UNITED STATES PATENT AND TRADEMARK OFFICE

APPLICATION NO.	FILING DATE	FIRST NAMED INVENTOR	ATTORNEY DOCKET NO.	CONFIRMATION NO.
10/538,542	06/08/2007	Max Aebi	001227/0208	3676

Office Action Summary	Application No. 10/538,542	Applicant(s) AEBI ET AL.	
	Examiner MICHAEL T. SCHAPER	Art Unit 3775

Fig. 6

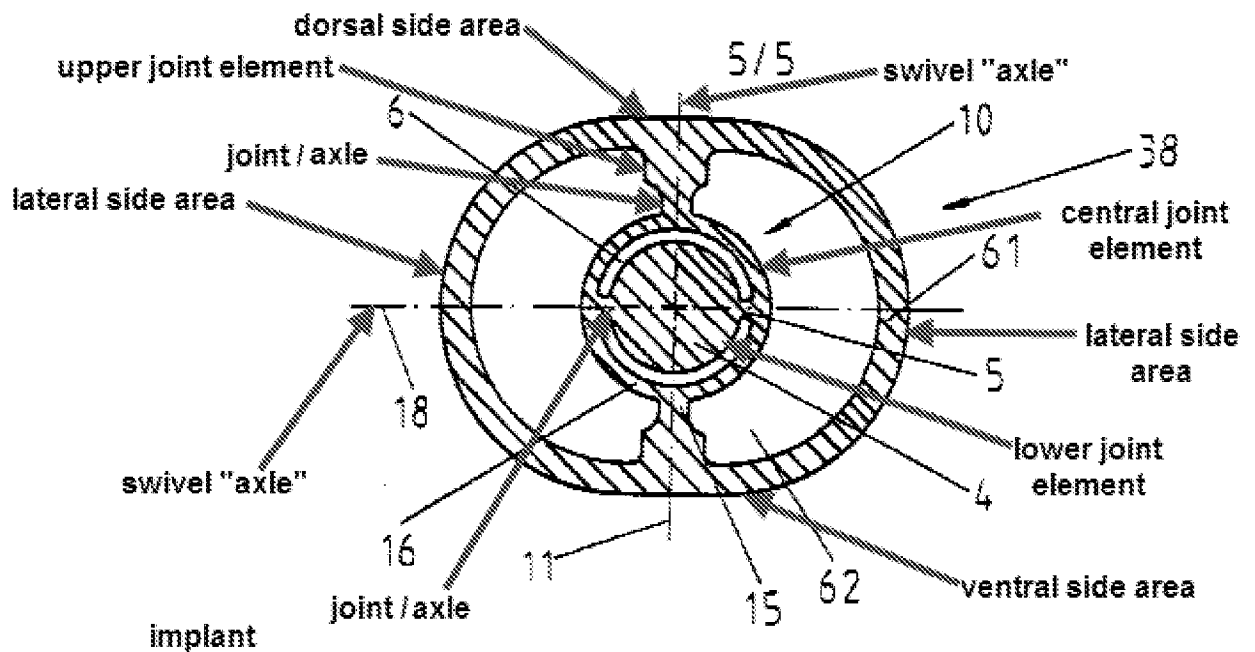
Frigg discloses an intervertebral implant (see examiner-annotated Figs. 6-7 above) comprising a central axis, an upper section, suitable for laying onto the base plate of a vertebral body lying above, and a lower section suitable for laying onto the cover plate of a vertebral body lying below, wherein the upper section has a ventral side area, a dorsal side area, two lateral side areas, a top apposition surface, and a bottom

surface; the lower section has a ventral side area, a dorsal side area, two lateral side areas, a bottom apposition surface, and a top surface; and the two sections are moveable in relation to each other via two joints arranged between the two sections, wherein each of the joints has a swivel axle and the two swivel axles are arranged transversely or perpendicular to each other; the two joints comprise an upper joint element connected with the upper section, a central joint element, and a lower joint element connected with the lower section; the central joint section is connected with the lower joint section by means of at least one axle coaxial to the swivel axle and rotating around the swivel axle and with the upper joint section by means of at least one axle coaxial to the swivel axle and rotating around the swivel axle; wherein the central joint element comprises a frame; wherein the central joint element is in the form of a cross; wherein the central joint element is in the form of an angle.

Frigg discloses the claimed invention except for a means being provided that is suitable for causing temporary blocking of the mobility of the two sections around the joint, whereby that the means comprises an insert with a lower end and an upper end and a depression in the surfaces at each of the two sections, which are open on the ventral side areas, and that the insert with its ends can be inserted into each of the depressions; wherein the means keeps the two sections, measured at their ventral side areas, at a fixed distance from each other; wherein the means can be attached to the two ventral side areas of the two sections; wherein the depressions are dovetail guides and the ends on the insert are arranged complementary to these dovetail guides; wherein the dovetail guides are tapered from the ventral side areas towards the dorsal
